Addendum

Oak Tree Liquor Store Exterior Renovation Project Number: 3035-17059-1

ADDENDUM # 1 **Date: October 26, 2017** **Page 1 of 12**

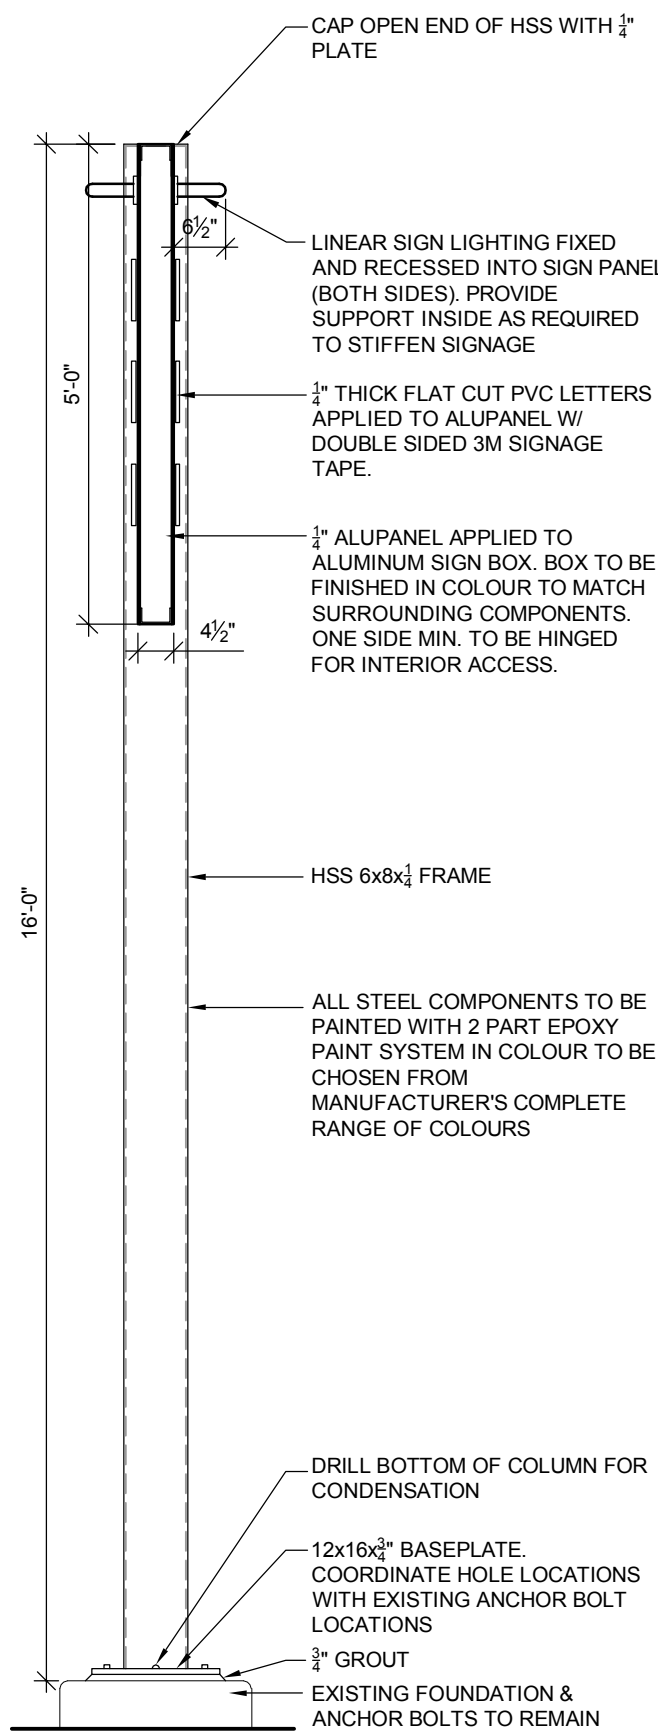
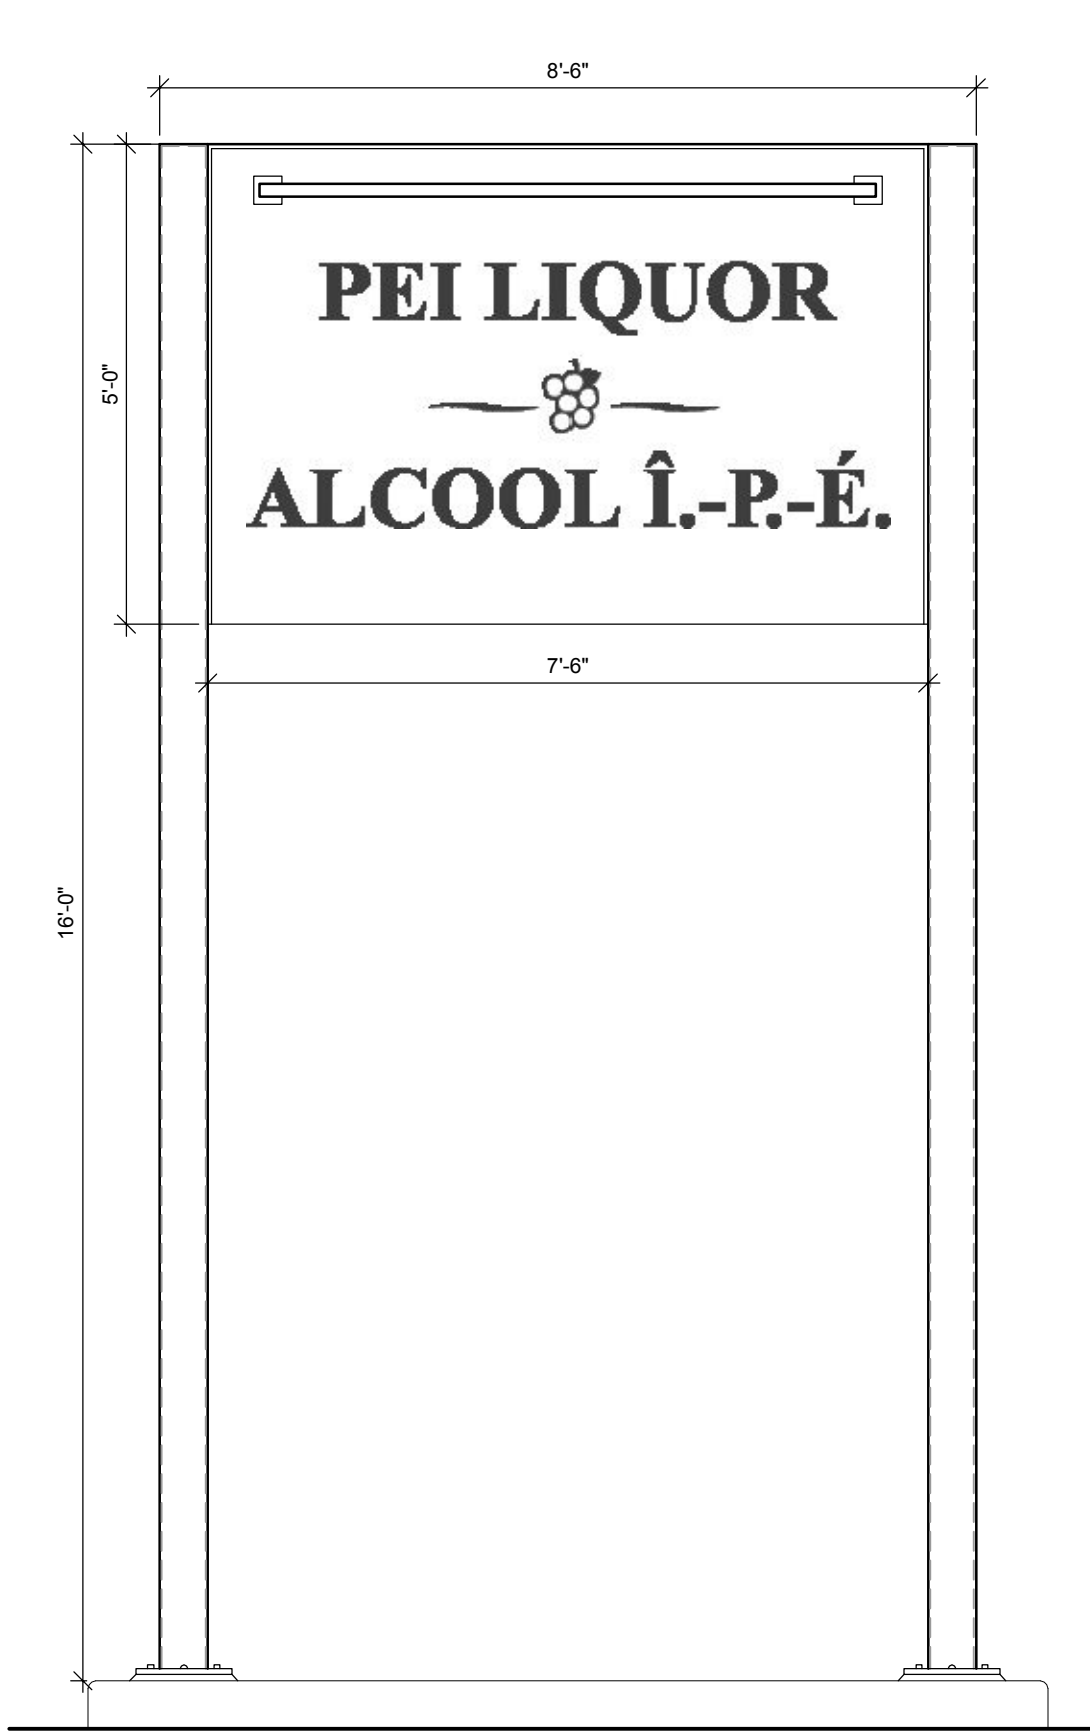
1. Please refer to appended sketch **ASK#001** for addition of a new Pylon Sign to replace the existing at the intersection of University Avenue and Pond Street. Contractor to allow for careful demolition of the existing sign construction as to not damage the components to remain.

2. Refer to Architectural sketch ASK01.

- b. Supply and install two (2) new type "W3" linear LED sign lights and mount to the new sign as indicated in ASK01. New luminaires are to be powered from the existing electrical feed that currently feeds the existing electrified sign. This contractor shall disconnect the existing electrical feed to the new sign to allow for its removal and then re-feed the new sign lighting from the existing feeder. Supply also a single power toggle switch as a isolating means and mount on the steel post as directed by the architect. New type W3 luminaires to be;
 - a. SPI, SEWS STYK series, Cat # SEWS-077-L43.0WF-35K-SMA-24VDC-LBK-006-AN08-PSE.
